March 31, 2011

Mr. Ming-Tai Chao, P.E.
Environmental Engineer II
North Carolina Department of Environmental and Natural Resources
Division of Waste Management
Permitting Branch, Solid Waste Section
1646 Mail Service Center
Raleigh, NC 27699-1646

Subject: Dare County
Dare County Construction and Demolition Landfill (C&DLF)
Construction Quality Assurance Report
Response to Comments

MOISTURE DENSITY RELATIONSHIP
ASTM D698-91 SOP-S12

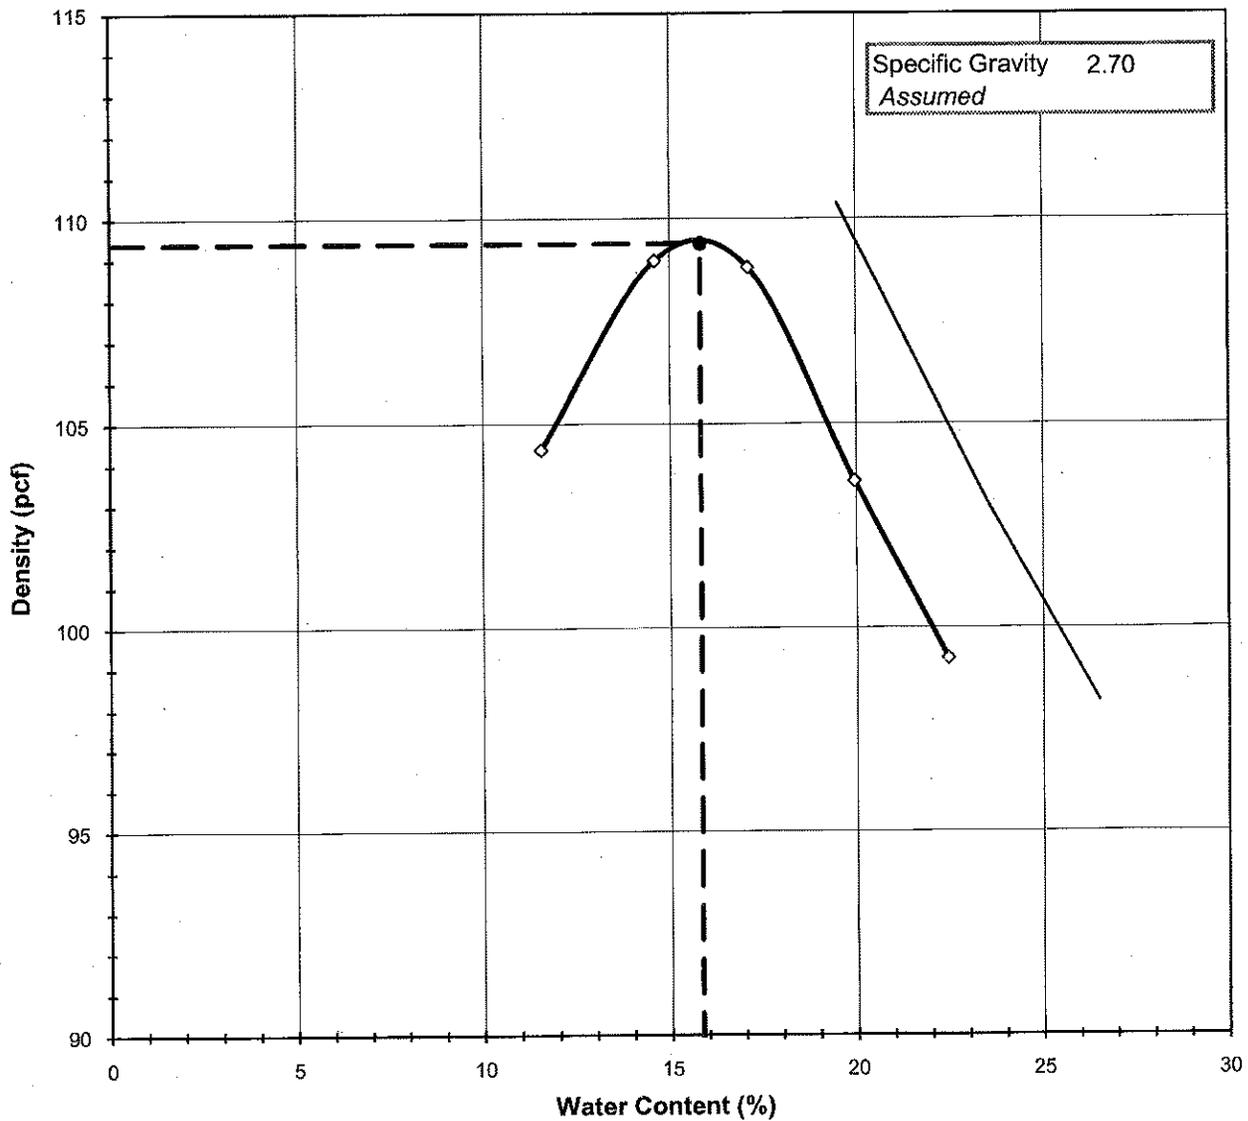
4. (Appendix A-6, Geotechnics Lab Data Sheet for Moisture-Density Relationship dated June 15, 2010. Boring No. ACRE 1; Lift 5; Lab ID 2010-652-09-03) The Sample Identification Number - Upper CF-01 is likely a typographic error of Upper CF-11. Please clarify.

*The QCL conformance test results for moisture density relationship with lab ID: 652-09-03, sample ID: Upper CF-01 and dated June 15, 2010 contain a typographical error with the sample ID and should read Upper CF-11. The revised moisture density sheets associated with this sample number are included in **Attachment No. 3.***

Onsite Upper Common Fill Moisture / Density Relationships

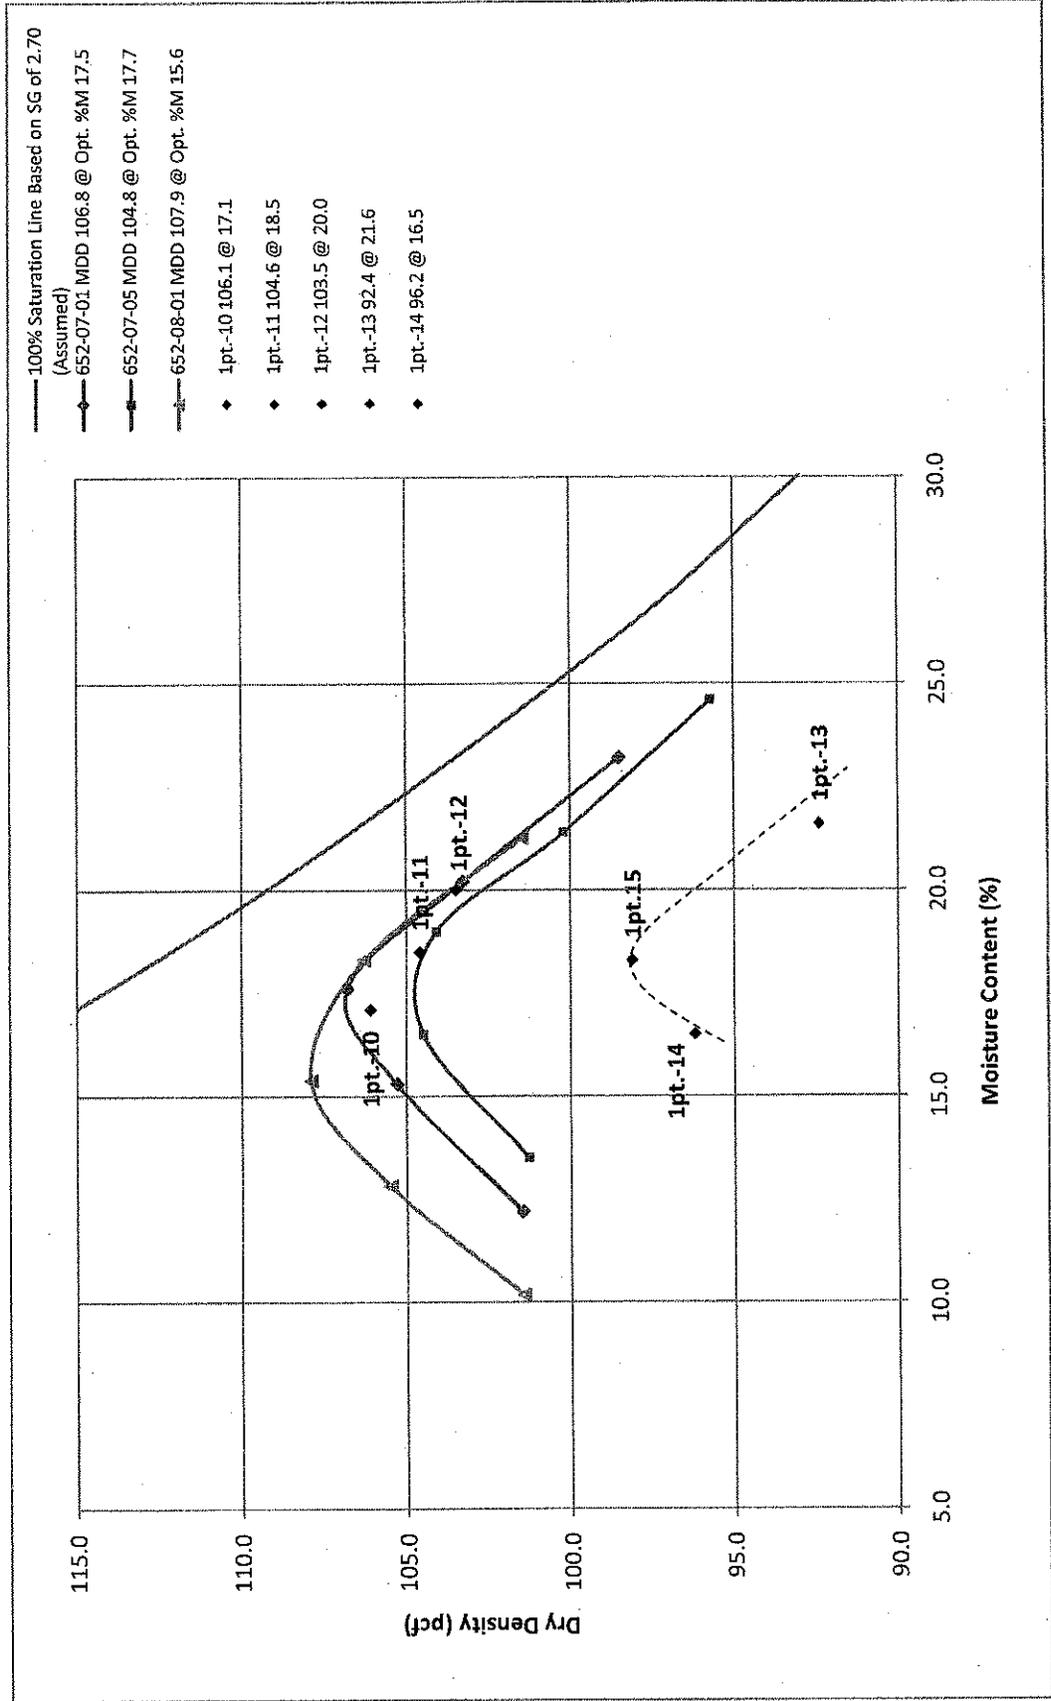
7. (Appendix A-7) In the Summary Tables (CFFDR-04, Page 2 of 15, dated June 7, 2010 & CFFDR-05, Page 1 of 8, dated June 9, 2010) the Proctor ID (652-07-02) and related moisture & density data are not provided in the CQA report. Please provide the data.

The CQC field data summary table for CFFDR-04 contained typographical errors in the proctor ID for test numbers ND-193 to ND-208. The proctor ID was revised to read 652-07-05. Additionally the proctor ID in the legend for the Upper Common Fill Moisture \ Density 1 point plot was revised. The revised sheets are included in Attachment No. 6.

PROJECT NO. 17952-56960
FILE NAME: SD-1
SHEET NO.
SD-1

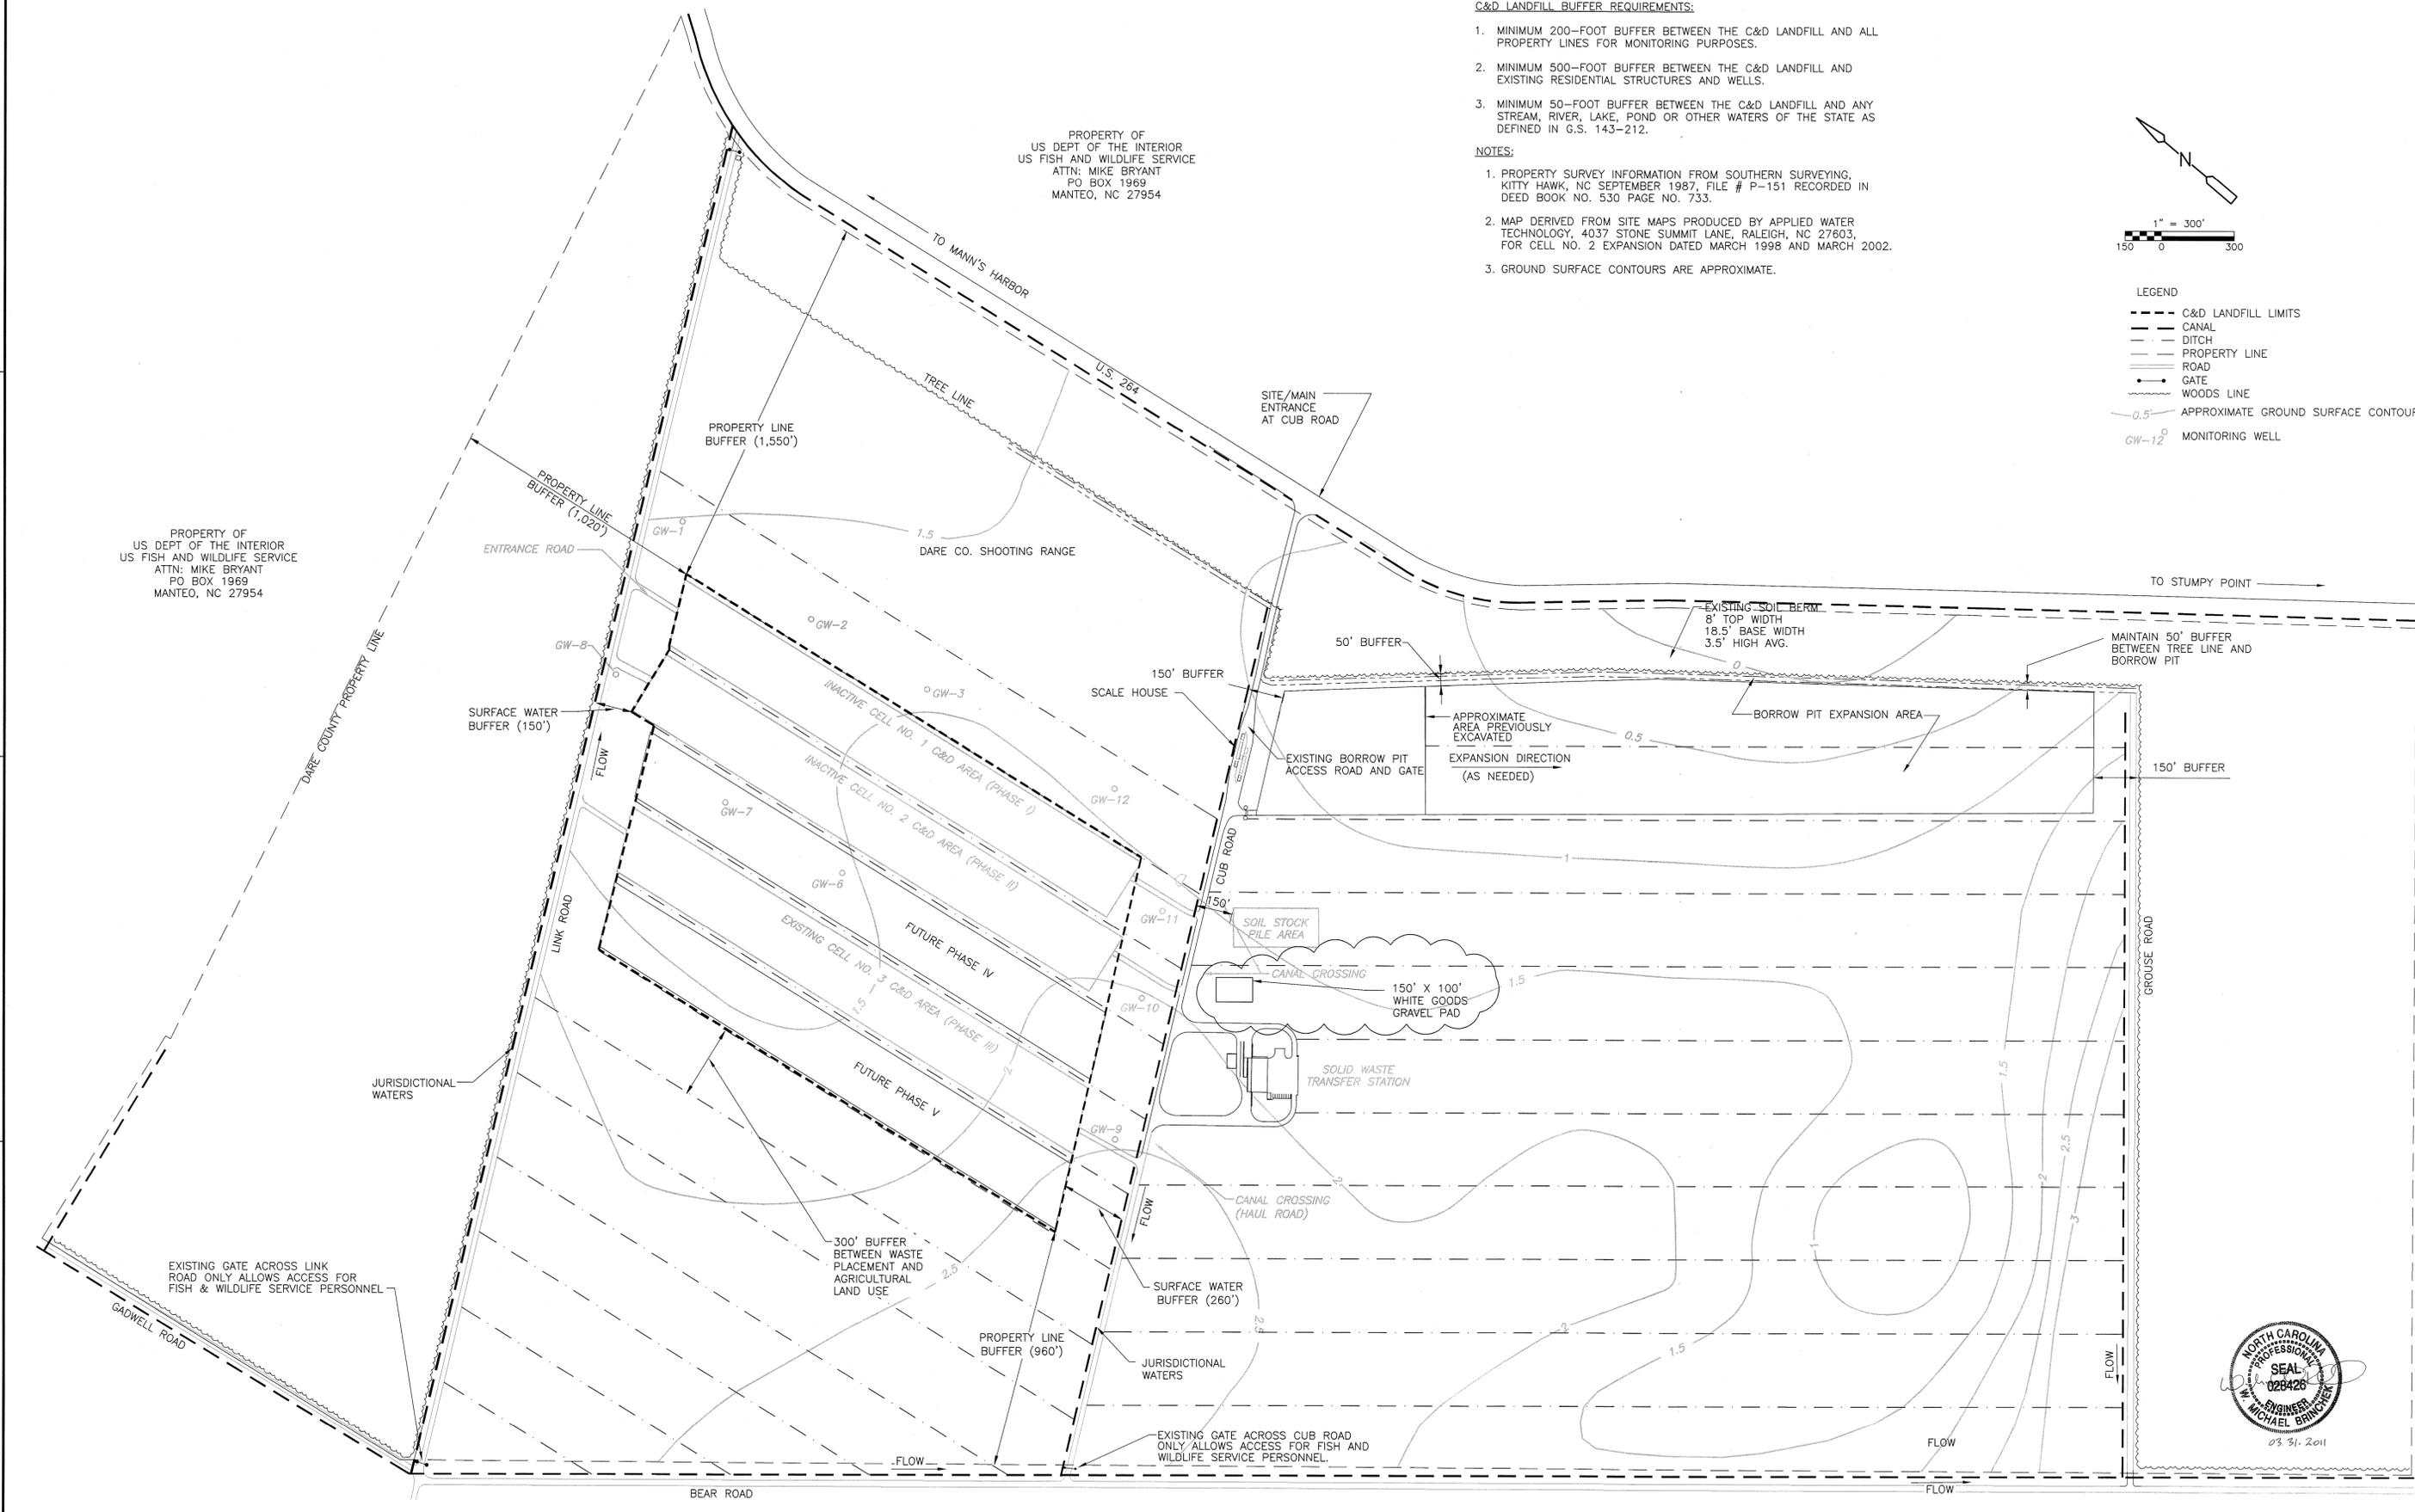
Additionally, in the February 14 2011 cover letter that came along with the CQA Report indicated that there were two pre-operational conditions of the Permit to Construct for Cell No. 4 had not been completed by the County at this time, which included:

1. Modification of the Operations Plan by adding the provisions and day-to-day management practices of recyclable material including, but not limited to, white goods/scrap metals, used/scrap tires as described in the December 31 2009 response letter (Doc ID 9246), prepared by CDM on

Section 7 of the Operations Plan was modified to include information regarding management of white goods and scrap tires. A revised Section 7 is included in Attachment No. 9. Additionally, Sheet SD-1 in the Facility Plan was modified to include the location of the white goods gravel pad. The revised Sheet SD-1 is included in Attachment No. 10.

REV. NO.	DATE	DRWN	CHKD	REMARKS
1	3/11	WPS	WMB	REV. FACILITY PLAN TO INCLUDE RECYCLABLE PAD PER NCDENR COMMENTS
